ADDENDUM NUMBER 1

Dated: January 12, 2012

Re: Canaan Valley Resort Renovations & Additions
Division of Natural Resources
Davis, WV
RFQ# DNRB12095

From: Paradigm Architecture
2223 Cheat Road
Suite 300
Morgantown, WV 26508
(304) 284-5015

BD01

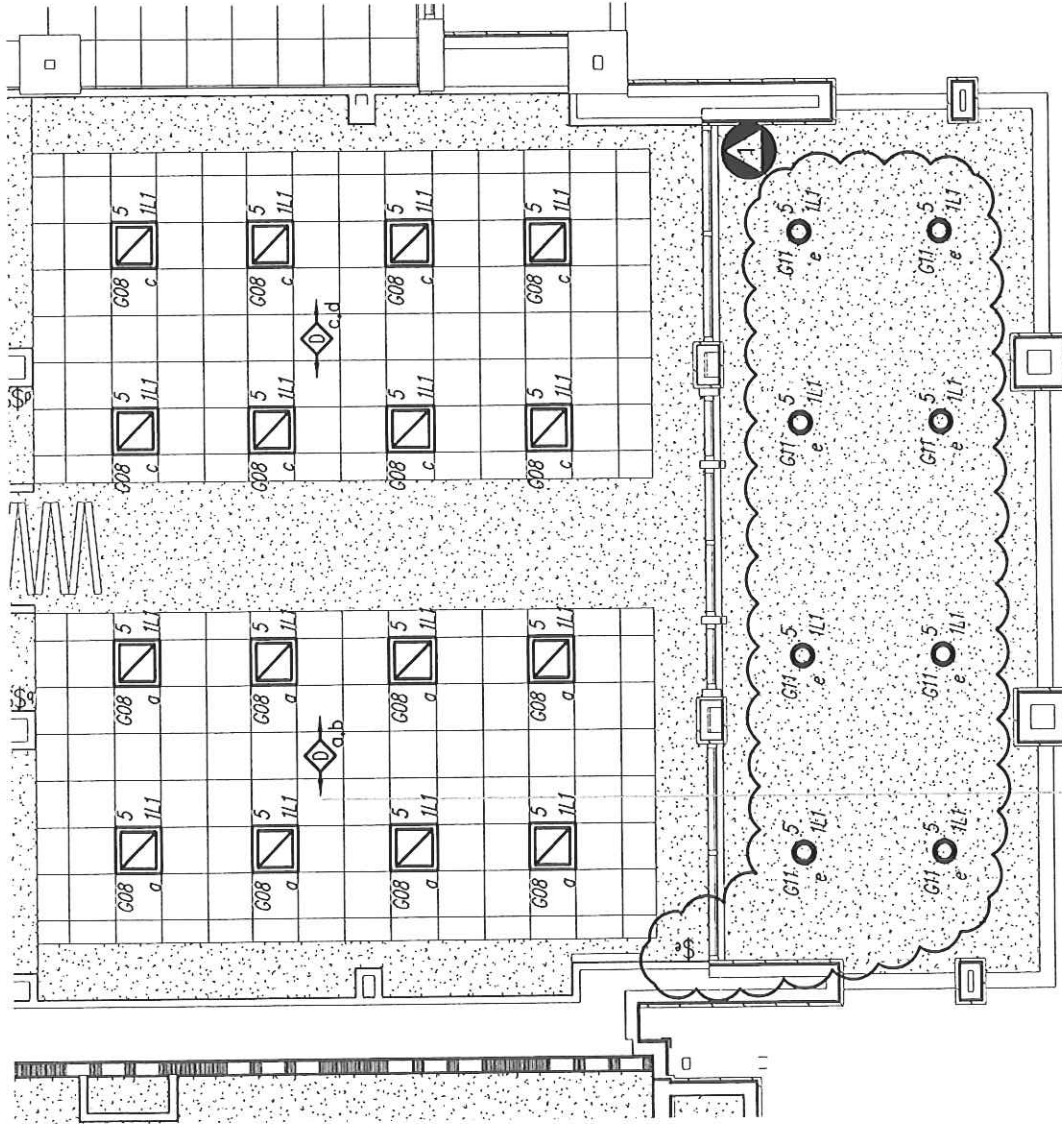
- Item 19:** See attached revised electrical drawing E2.13 and bulletin drawings BD01 and BD02.
- Item 20:** See attached architectural bulletin drawings BD03, BD04, BD05, and BD06.

10A Typical Balcony Bracket
3/4" = 1'-0"

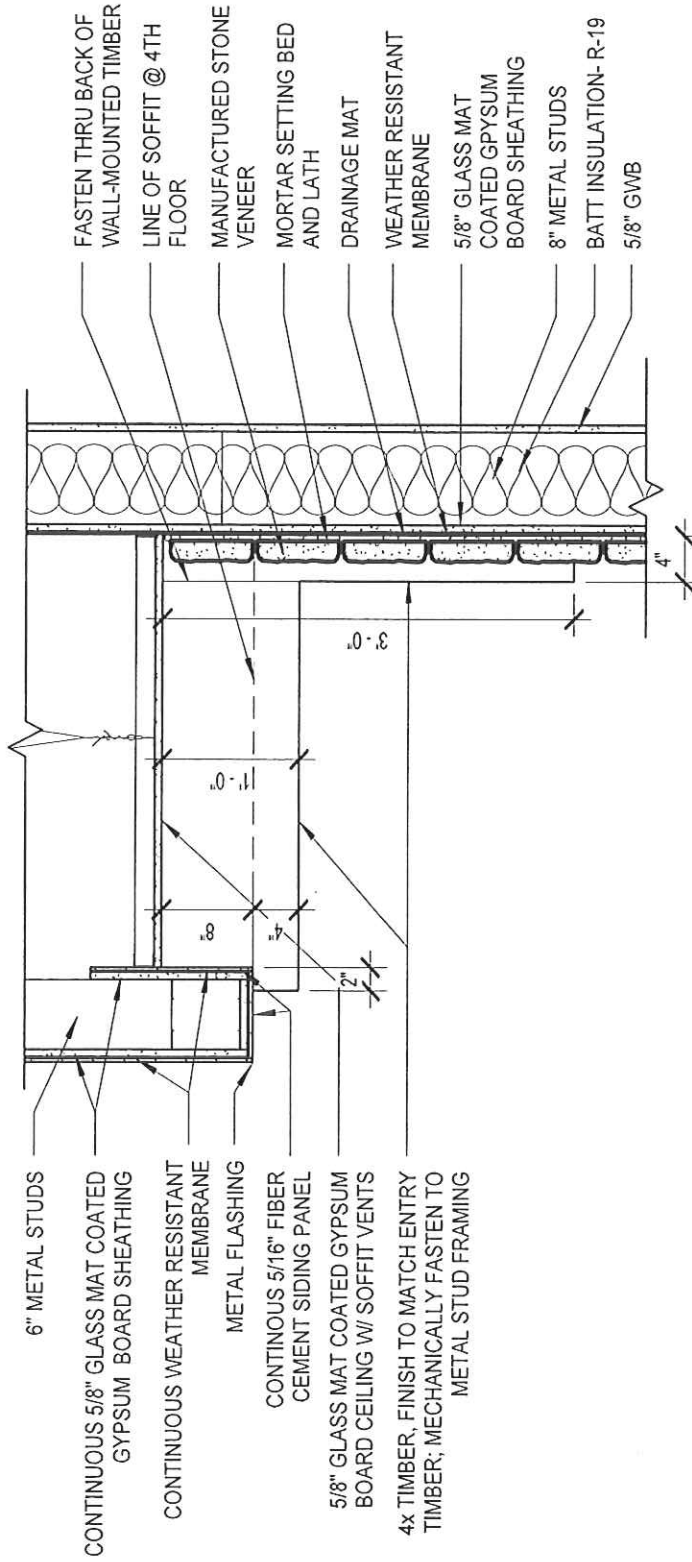
ADD DETAIL 10A TO SHEET A5.03

**ADD DETAIL 5B TO
SHEET A2.68**

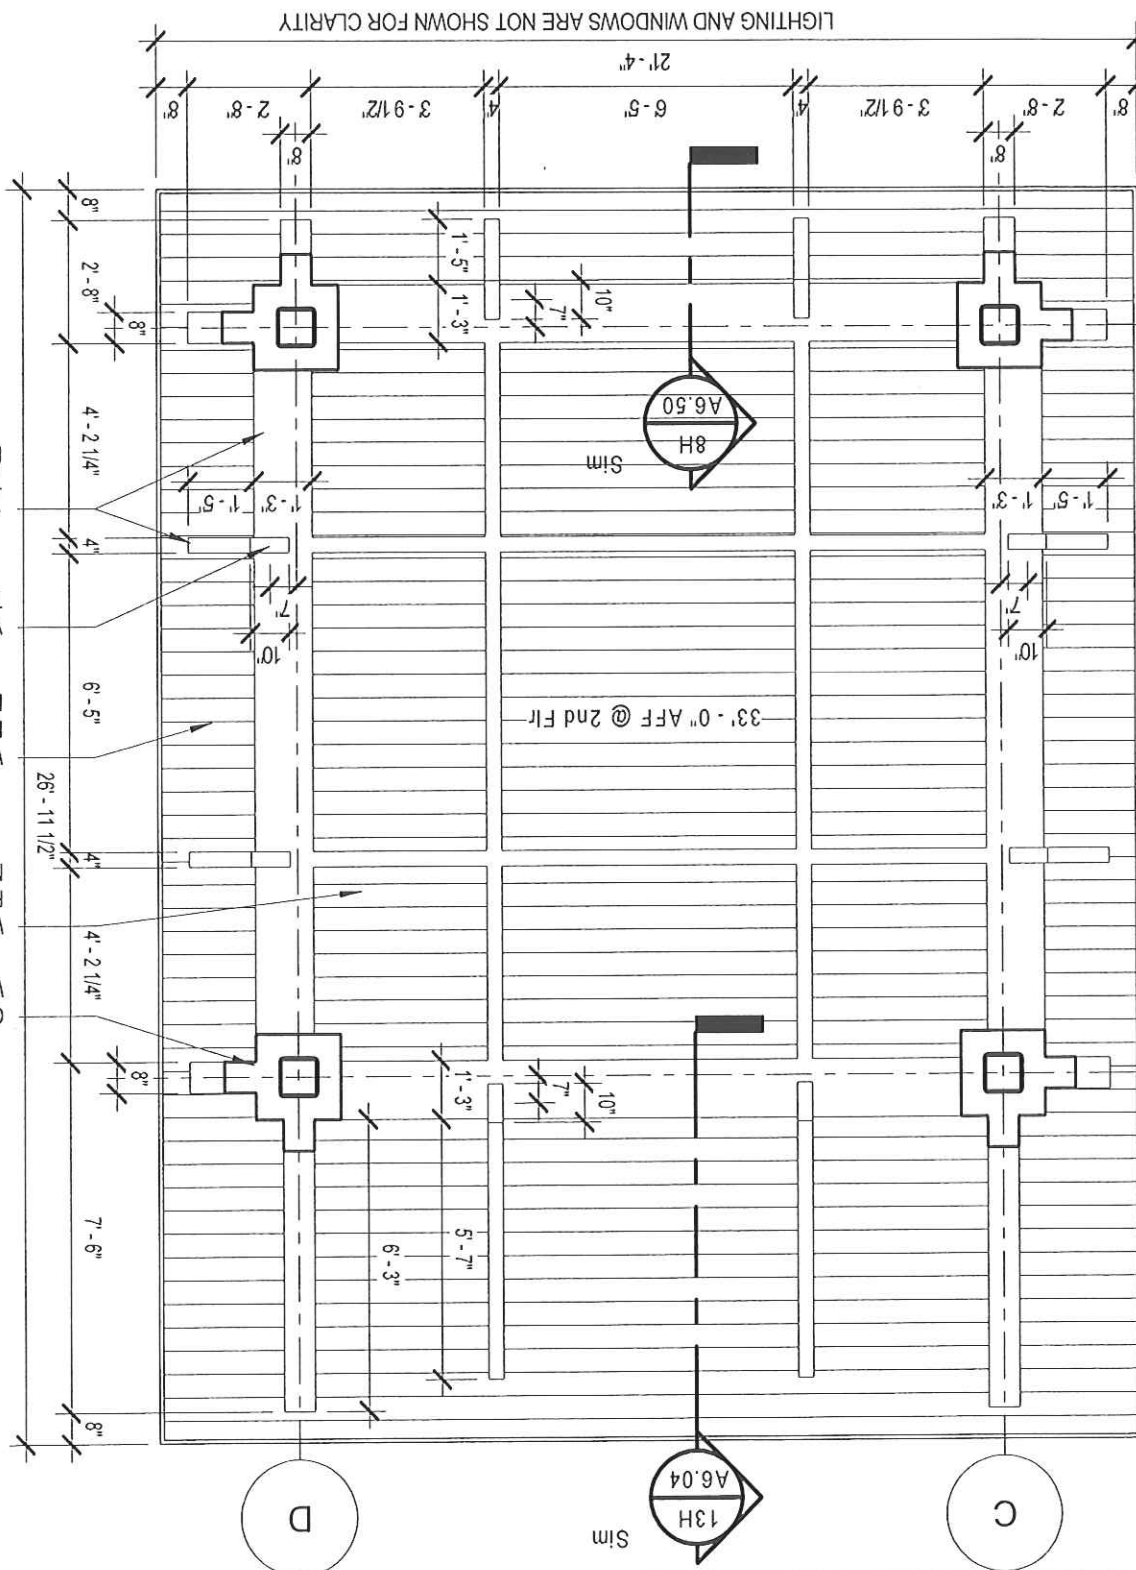
Question 37: None of the timber work at the new main entry clerestory is detailed or dimensioned on either the architectural or structural drawings. Provide construction drawings for pricing.

Answer: *See attached Reflected Ceiling Plan with notes. Plan details are located on A9.00.*

7F	Curtain Wall Jamb Detail	A4.52	1 1/2" = 1'-0"
----	--------------------------	-------	----------------

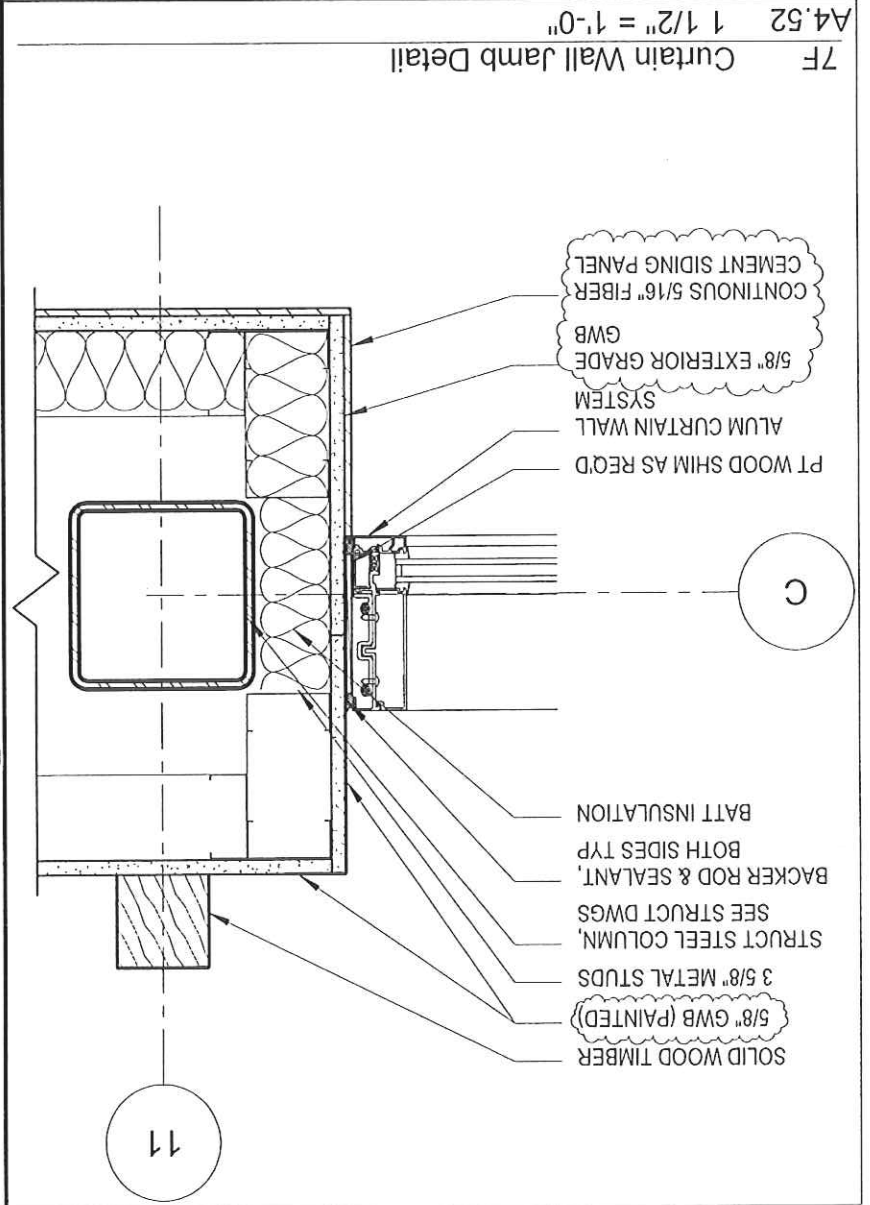
Question 38: 10D/A4.01 - provide a section above the stone work showing the column/pilaster construction. Detail 7F/A4.52 which is labeled as a similar detail/location on drawings A5.50 shows different construction. Adequate details for pricing and construction have not been provided for work in this area.

Answer: *See attached revised 7F/A4.52 and 10D/A4.01.*

Canaan Valley Resort Renovations and Additions

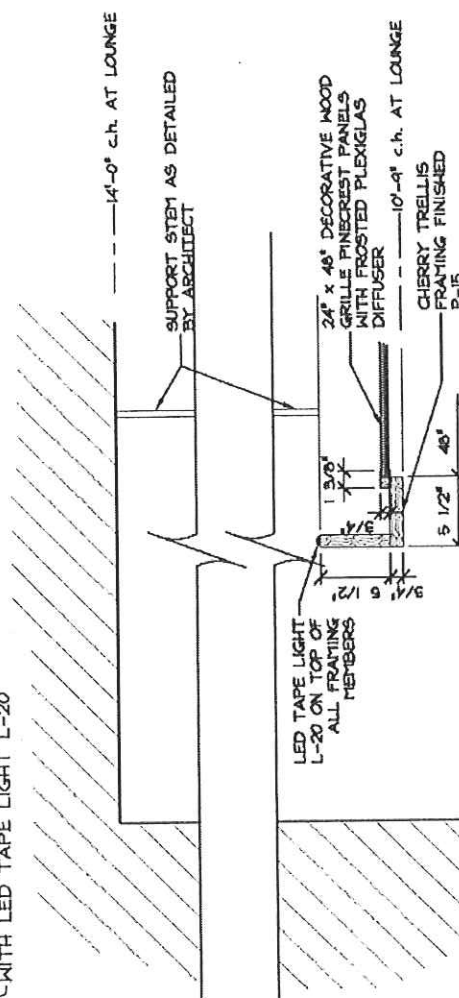
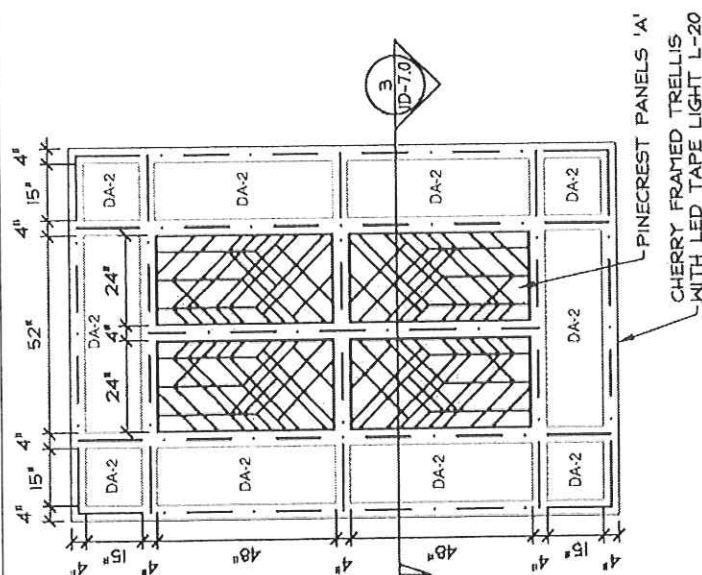
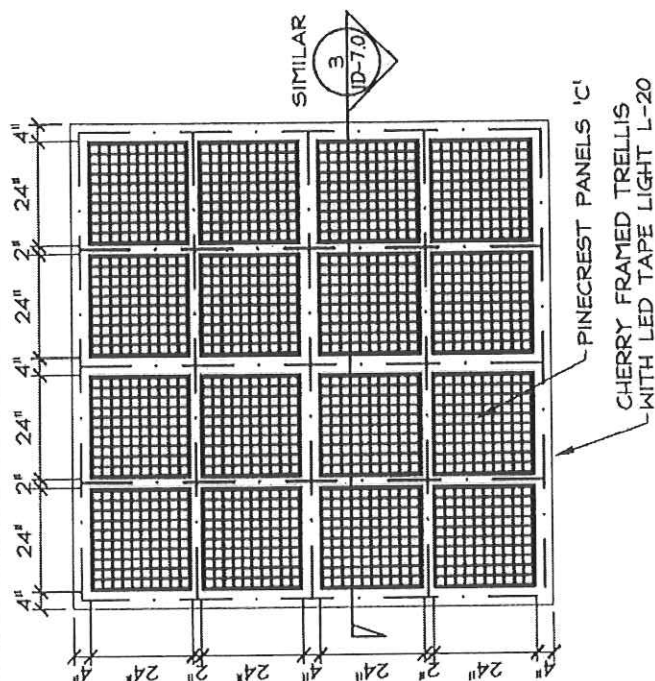
Question 35: Provide all construction details and ceiling sections, referenced on ID-6.0.

Answer: *Details referenced on ID-6.0 are included on bulletin drawing BD09. ID-7.0 will not be issued as part of this project.*
